## REFERRAL REPORT

TO: Vancouver City Council  
FROM: General Manager of Planning, Urban Design and Sustainability  
SUBJECT: CD-1 Rezoning: 3084 West 4th Avenue and 2010 Balaclava Street

**Figure 4: Site Plan**

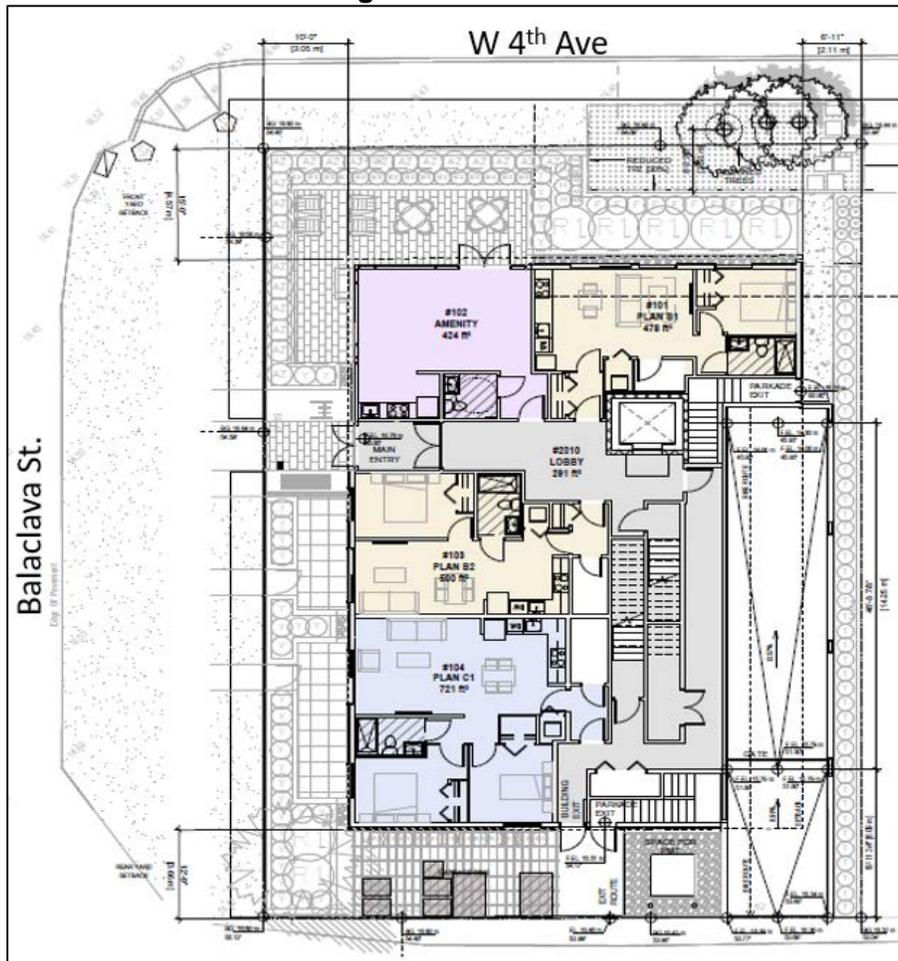
The residential entry is on Balaclava Street, adjacent to the indoor and outdoor amenity space at the northwest corner. The siting of the amenity space at grade helps activate the public realm and create opportunities for social interactions. The building is setback 3.05 m (10 ft.) from Balaclava Street which provides space for individual entries and patios to ground-floor units.
